R E M A R K S

In response to the Examiner's comments in the Final Rejection:

Annotated Sheet Showing Change

FIG. 4

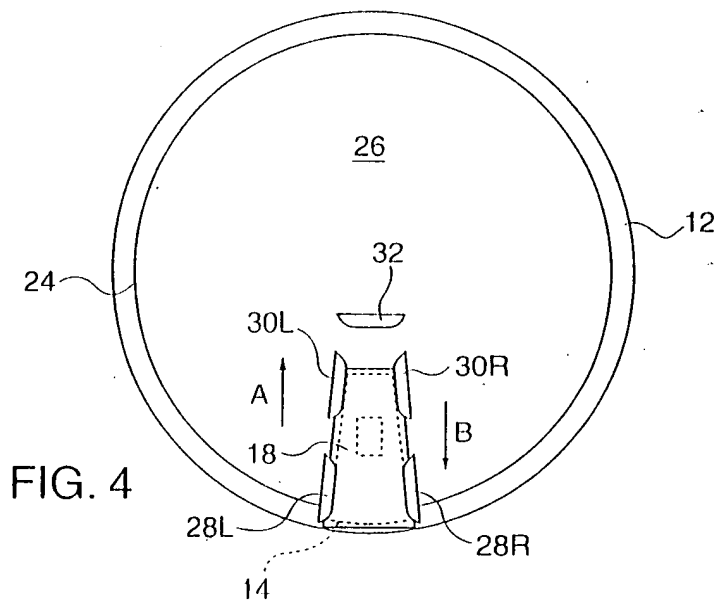
The Specification has been amended at Page 5 to clarify that FIGURE 4 shows an underside view of the closure lid of FIGURES 1-3 helpful in an understanding of the invention. The Specification has also been amended at Pages 7 and 8 with respect to FIGURE 5, indicating that the panel door freely slides between the pair of grooves and the underside of the closure lid. (This is carried through in the submitted Amendment to the Drawings.)

FIG. 5

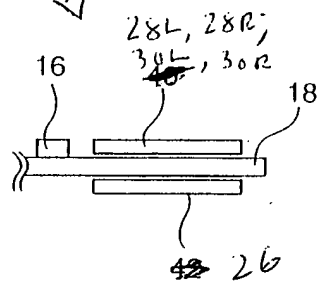
- a. Claims 9, 10 and 16 have been amended to correspond with the Examiner's suggestions and to clarify some of the objections raised; and
- b. Pages 5, 7 and 8 of the Specification have been amended to clarify the drawings and deal with the objections to FIGURE 5.
